OICA Comments to GRE/2017/17 and GRE/2017/22

OICA Statement regarding GRE/2017/17 and GRE/2017/22

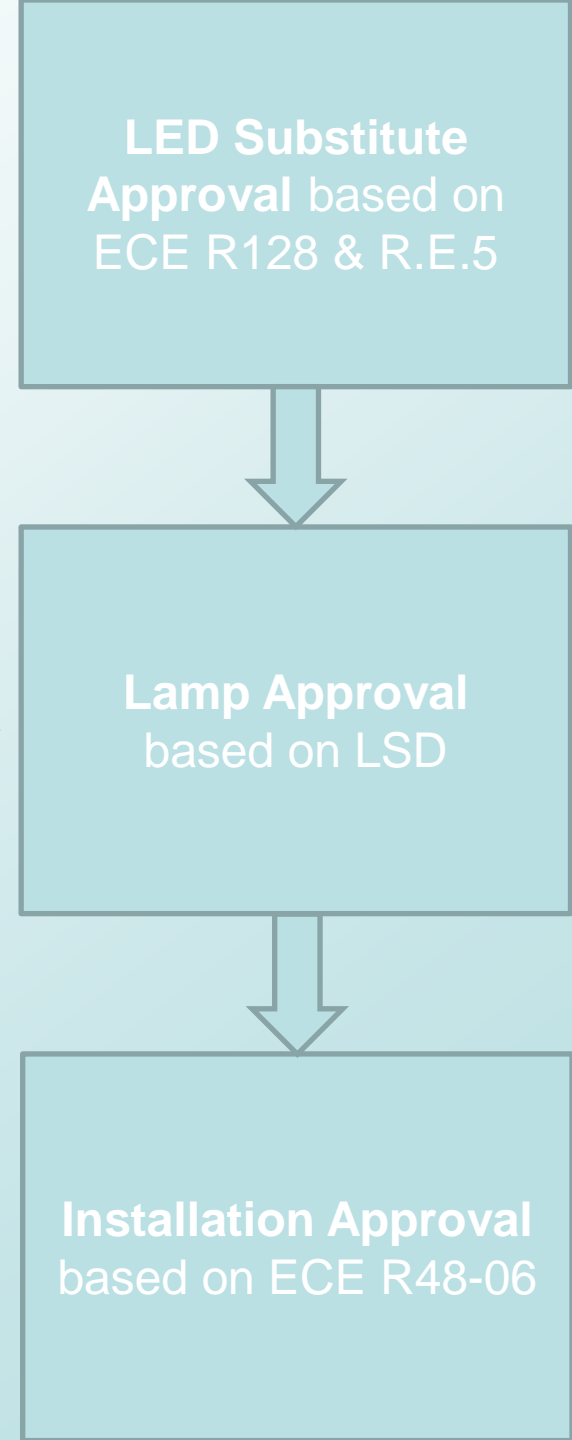
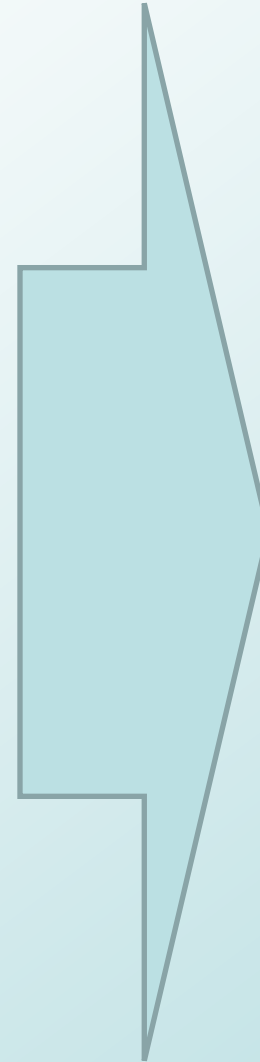
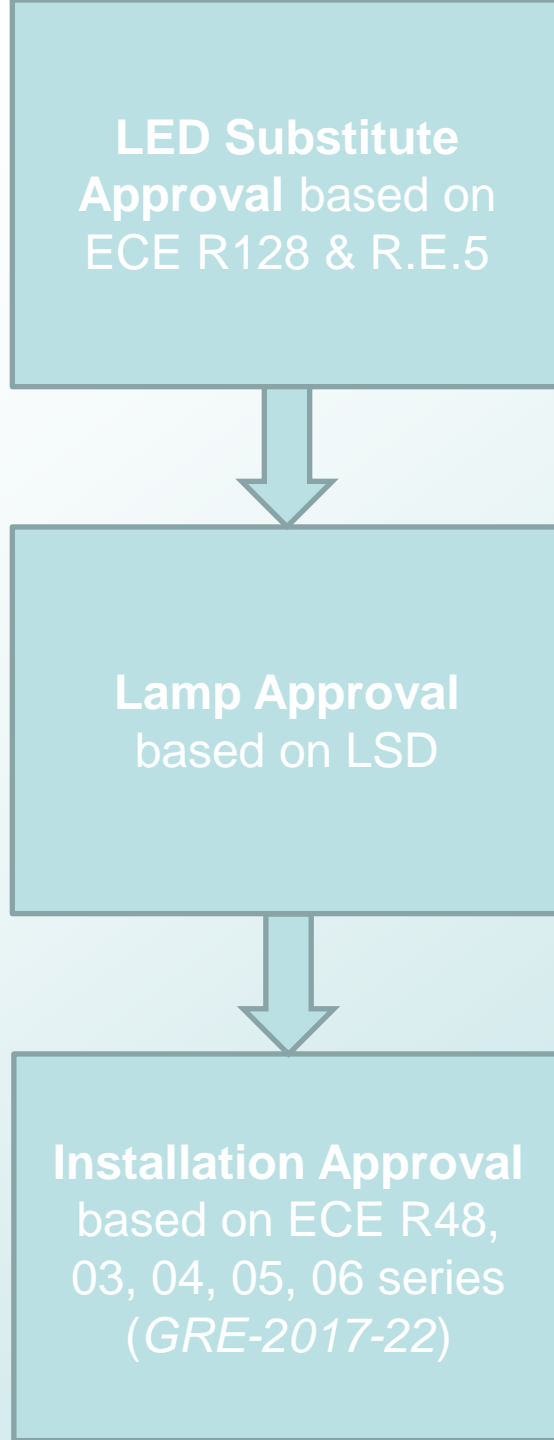
**LSD is only introduced
for
ECE R48-04/05/06
(GRE/2017/11 /
GRE-78-14/GRE-78-15)**

~~Installation Approval
based on ECE R48-03~~

Where a vehicle manufacturer sees potential problems with installing LED substitutes on a previously approved UN R48/03 or 48/04 vehicle type an extension of the approval maybe necessary in order to prevent the vehicle manufacturer being held accountable for misuse.

That would be an unacceptable burden for the vehicle manufacturer !
